Modine Commercial Technical Bulletin

Subject: Upgrade Condenser Fan Motor MCB's

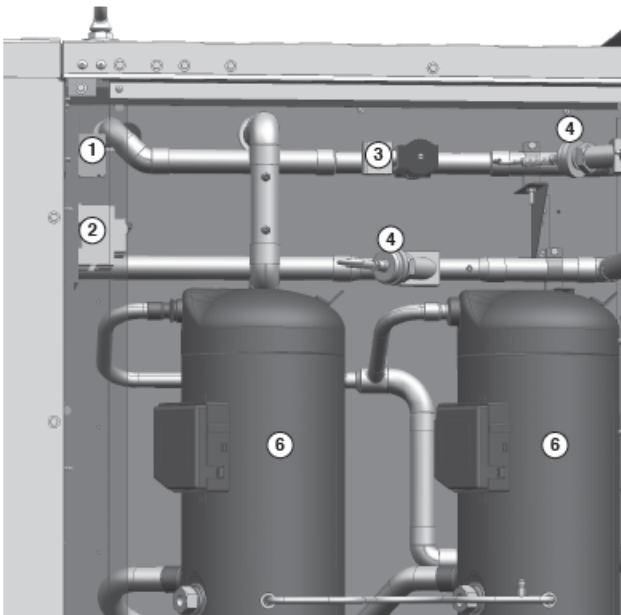
The Atherion Commercial Packaged Ventilation Unit, model MPR is designed to provide many years of trouble-free service in demanding conditions. However, the condenser fan circuit breakers in older units experience nuisance tripping in conditions of high cabinet temperature. It has been determined that those units had breakers that were undersized for their role. To correct this, Modine is supplying upgraded breakers that will enable the model MPR to perform as designed.

- Sales Order Number/Job Name
- Model Number
- Serial Number
- Breaker Rating
 - Note: Breaker rating will be stamped on the front of the breaker. These breakers are located in the compressor section pictured as item #2 below. Be sure to follow required precautions and equipment lockout procedures prior to opening cabinet doors.

Depending on the existing breaker size, a suitable upgrade will be selected and provided as a no-charge warranty part.
